Our ref: P680020-FRA L04
 Your ref: 21/02286/F

Re: Construction of a coffee unit with drive-thru facility and indoor seating with associated access, car parking, landscaping and servicing parking. Land North West of Launton Road roundabout adjoining Skimmingdish Lane, Caversfield

Please find attached a copy of the updated Flood Risk Assessment for the above application site. This letter and associated FRA report has been produced to reflect the consultation responses from the Environment Agency (dated 2nd September 2022, Environment Agency Ref: WA/2021/129266/04-L03) and our replies and updates since the original submission included as Section 4 of the FRA (680020-R1(03)-FRA, October 2022).

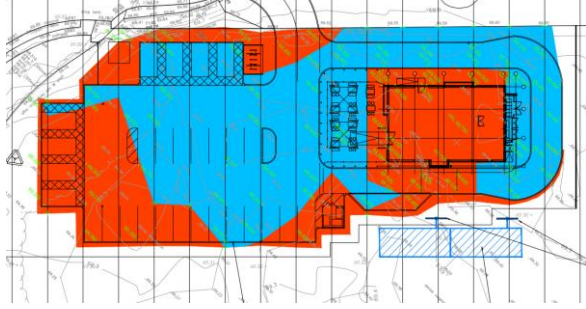
<p>It is still difficult to understand if the scheme would be hydraulically connected. For example, from comparing the spreadsheet values and the Layout Plan, it appears that the 2.88m³ of proposed volume between 69.16-69.26mAOD on the main development site would not be accessed until a flood level of approximately 69.30-69.33mAOD is reached. No commentary on this has been provided, but it appears that sufficient compensation is provided for this lowest slice (69.16-69.26mAOD) by lowering areas of raised land outside the main development site as shown on the Flood Volumes Section Layout Plan. We request</p>	<p>Drawing reference 220029_FV100_P7 and 220029_FV107_P3 (Extract below) show the site and the wider area floodplain offset and gain. The blue areas show where additional floodplain volume is created and the red where levels have been raised and volume is offset.</p>

Environment Agency Comment	RSK Response
<p>that further clarity is provided on this and how the compensation is hydraulically linked at other levels/slices.</p> <p>This can be shown by including plan/s which clearly mark the extents of each compensation slice so we can visually see how they are hydraulically connected. These extents should be based on the exact areas the applicant is lowering for each slice. It is not possible to view the individual compensation slices in the applicant's submitted plans.</p>	 <p>It can be seen from the spreadsheet that for each 100mm increment between 69.09m AOD and 69.69m AOD there is additional floodplain storage, once the flood level reaches 69.69m AOD, there is a displacement of floodplain for this 100mm increment, hence the requirement for additional attenuation at this level – in the form of the storage tanks.</p> <p>The level for level compensation is being provided in the underground tanks with the inlets set at the required level to provide the level for level compensation and allows for hydraulic connectivity to the floodplain when the flood levels reach these inlets (see above extract). It can also be seen from the cross sections that the flood levels enter the car park, so whilst there is some displaced floodplain volume in some areas, there remains a hydraulic connectivity between all sections of the site and the flood zone, therefore the plans and associated calculations show a true representation of the situation.</p> <p>It can be seen from the spreadsheet and the associated additional attention tanks that at all flood level increments, there is an increase in floodplain volume as a result of the development.</p> <p>In terms of hydraulic connectivity, the flood extent in the area encompasses the site, therefore any displaced volume in this location will retain a hydraulic connectivity to the flood plain and the watercourse either by the way of overland flow through the car park or by way of the drainage system.</p>

The previous drawings submitted to support this application showed a kerb aligned along the eastern side of the car park. Following the consultation with the EA, we have assessed the situation and removed the kerb from the development proposals (highlighted location in the above extract) to aid in the hydraulic connectivity between the site and the flood plain. The boundary of the car park will now be defined by a knee rail, ensuring optimum hydraulic connectivity.

No impediment to ingress of flood water – water level will rise and flow into site in between sections 9 and 15 (highlighted location in the above extract).

Further to this the control device and flood compensation tank are located within the flood plain at the agreed levels so as to ensure hydraulic connectivity is maintained.
